Electrical Energy & Safety Audit Report of Mangaldai College, Mangaldai, Assam

Audit Period: 08/11/2023-22/11/2023

Audited by: MRINMOY BORUAH ENGINEERING
Audit team led by: Mr. Mrinmoy Boruah,
Chief Energy Auditor and Electrical Consultant
Cell-phone: 9101043120, Email: mrinmoyboruah@gmail.com

Fig: SLD of main power distribution circuit

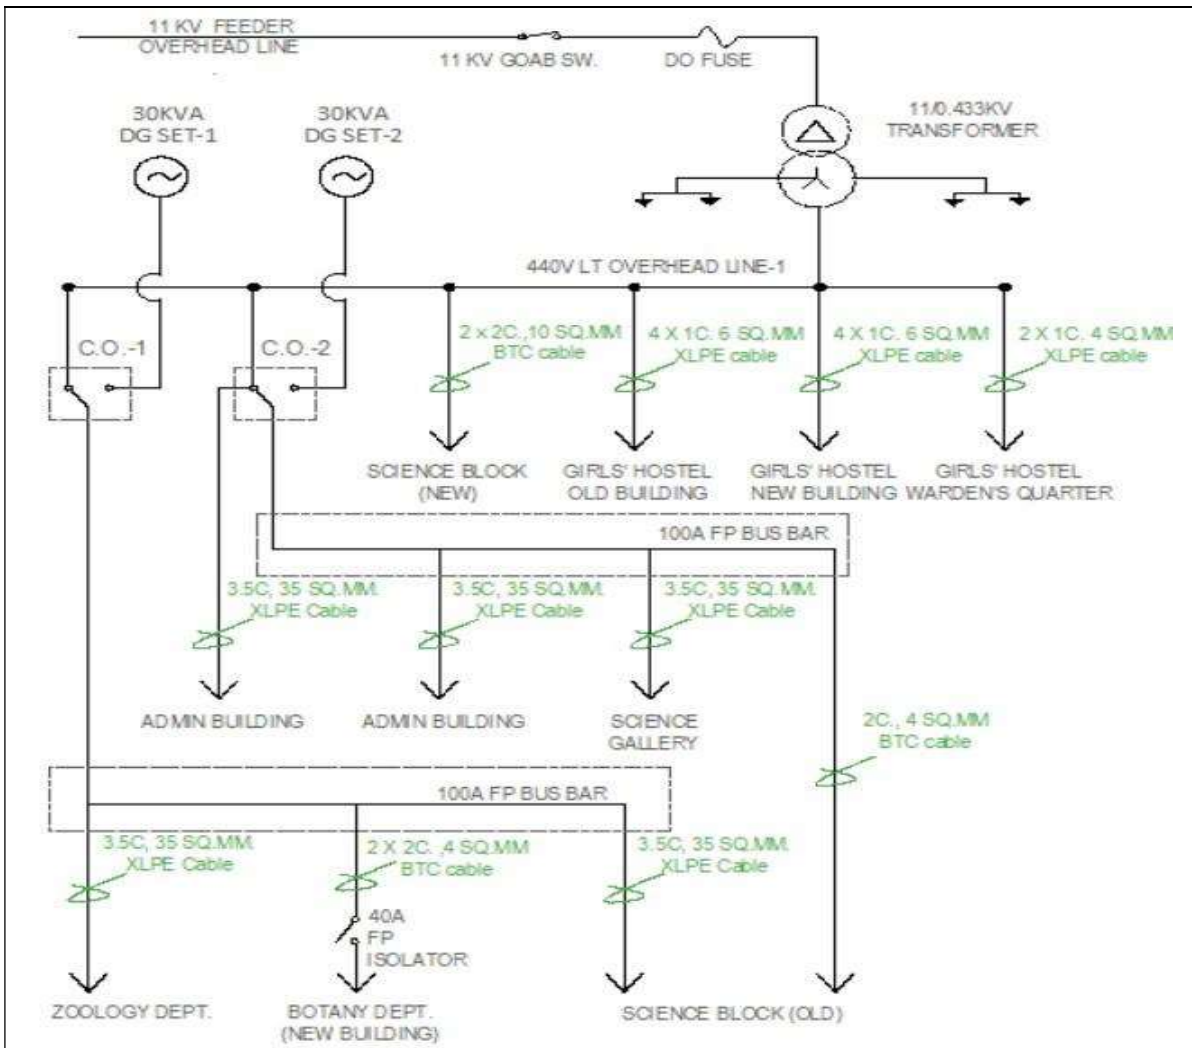
At present there is no Single Line Diagram of power distribution circuit available for verification. During the audit we had traced out the power distribution circuits to the extent possible.

The existing power distribution circuits should be traced out and a single line diagram representation of the same should be prepared. A mandatory approval of the final SLD is to be secured from the office of the Chief Electrical Inspector cum Advisor, Govt. of Assam. It is a safety rule/measure for enabling easy tracing of electric circuits in case of any trouble and for any necessary alteration in the power distribution arrangement.

Fig: Average Voltage Profile – Grid supply

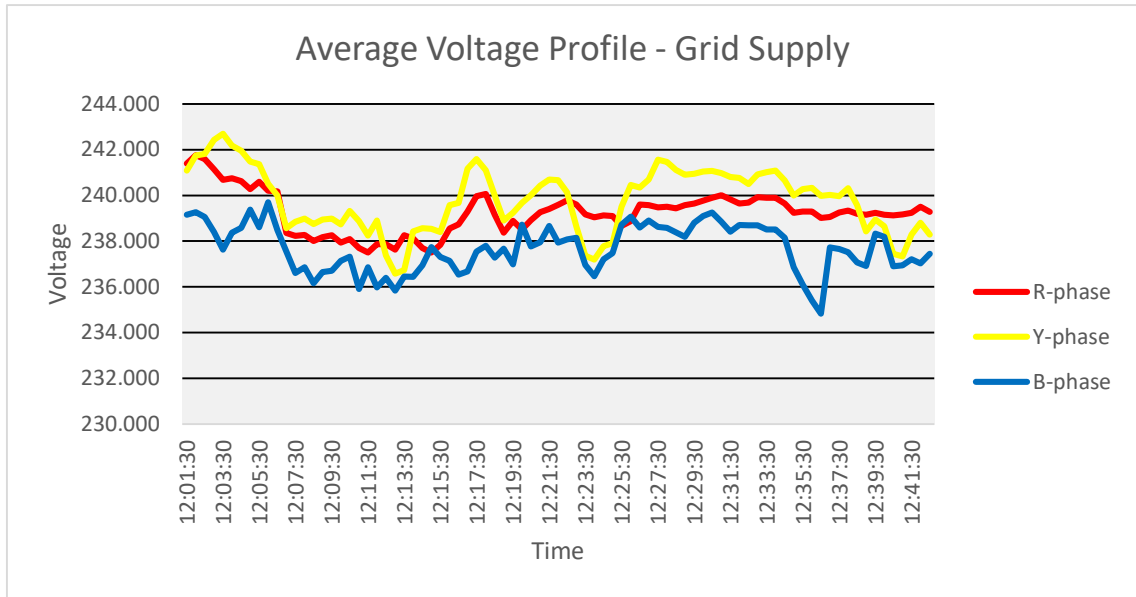
Parameters		Value	Variation (%)	Limit	Remarks
Voltage	R-Phase to N	239.242	0.32%	6%	OK
	Y-Phase to N	239.797	0.08%		OK
	B-Phase to N	237.677	0.97%		OK
Frequency		49.981	0.04%	3%	OK
THD-V	R-Phase to N	2.23%		3%	OK
	Y-Phase to N	1.64%			OK
	B-Phase to N	1.73%			OK
THD-I	R-Phase to N	21.59%		15%	Marginally high
	Y-Phase to N	65.99%			Very High
	B-Phase to N	23.27%			Marginally high
Neutral to Ground Voltage		5 V		3V	High

- The transformer's voltage output was found to be within limit.
- The supply frequency and its variation was noted to be within limit.
- The Voltage THD levels were found to be within limit.
- The Current THD levels of the Grid supply were found to be **very high**.
- The neutral to ground voltage was found to be high. The earthing arrangement needs to be improved.

Fig: Average Voltage Profile – DG set-1 supply

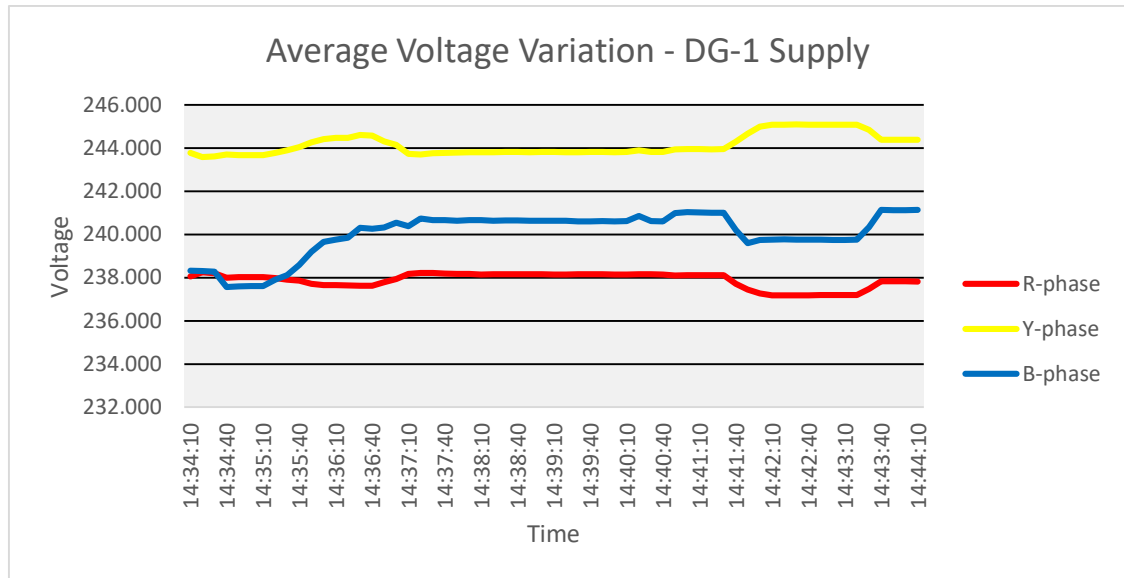
The average voltage at the DG set’s output as can be seen in the graph above is 240.69V (L-N). The voltage variation was found to be within 237.18 to 245.1 V. The DG set-1’s supply can be considered safe for operation.

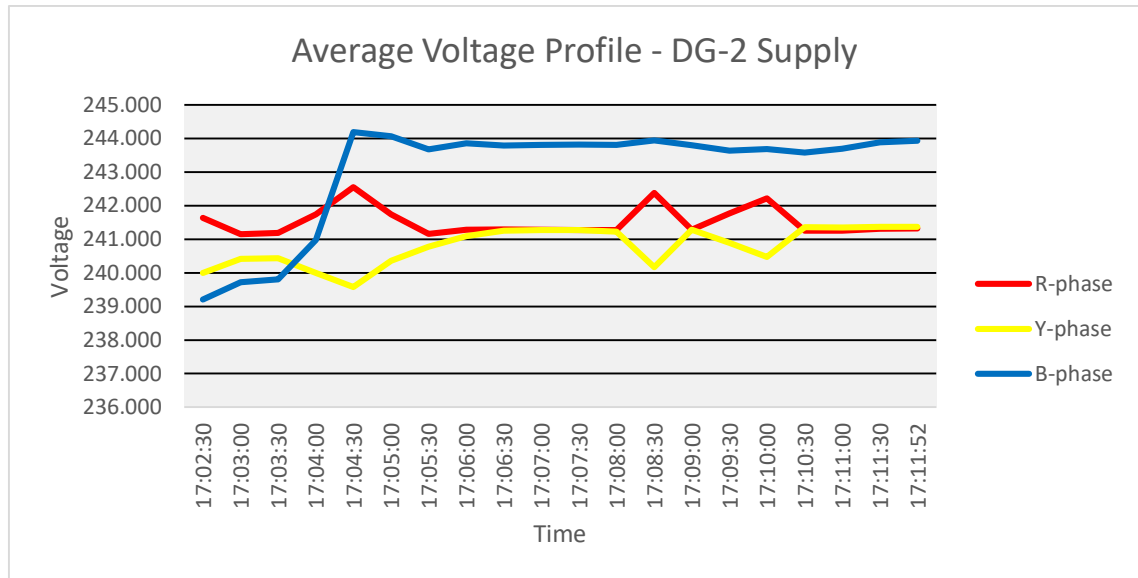
The average voltage at the DG set's output as can be seen in the graph above is 241.78 V (L-N). The voltage variation was found to be within 239.21 to 244.19 V. The DG set-2's supply is varying but may be considered safe for operation.
